RE: Oldcastle Coastal Facility – 1200 NW 18<sup>th</sup> St., Pompano Beach, CPTED/Security Public Safety Plan

I have been contracted to review the drawings for security and Crime Prevention Through Environmental Design (CPTED) features in the proposed Oldcastle Bonsal Facility site plan update that is being considered for permitting by the City of Pompano Beach.

Signage creating notice of premises being monitored and under surveillance.

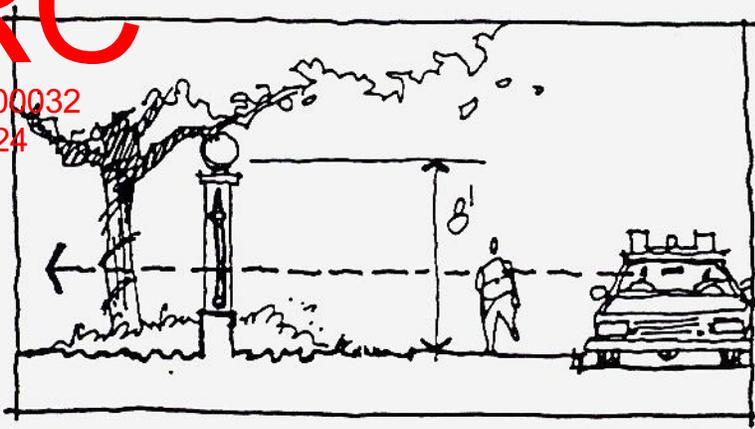
Signage – It is recommended that additional legally qualified posted warning trespass signage be added on the perimeter fencing and the new and improved entrances. Groundrules signage is critical for achieving compliant behavior of employees and visitors. The present signage is unclear and does not meet the legal criteria for enforcement. In addition, no-trespass signs should cite local ordinance statute, and who is enforcing the trespass (Pompano Police or Broward’s Sheriff’s Department). The new proposed no-trespass signs will be posted on the site perimeter fencing every 100 feet and within the parking lots. Trespassers cannot be successfully arrested and prosecuted if the notice is not properly worded and posted. There should also be signage that the facility is under video surveillance, which serves as a notice to trespassers and criminals.

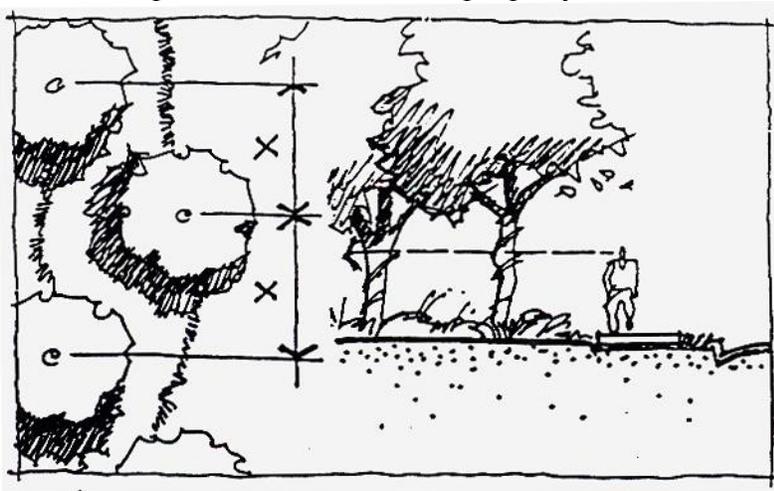
Natural surveillance – Natural surveillance is accomplished on the site by having a chain link fence on the north, south, and east boundaries. The west side boundary is being proposed to have decorative attractive code compliant decorative fencing and vehicular gates to create an entrance that allows open visibility by employees and staff and video surveillance. Police patrol will be able to readily discern any inappropriate or suspicious activity on the exterior of the fence, and see over the low shrub boundary, and under the tree canopies.

Ground plantings and hedges should be less than 3 feet and tree canopies over 8 feet to allow a clear zone of natural surveillance for police to be able to have un-obscured sight around the perimeter and into the property.
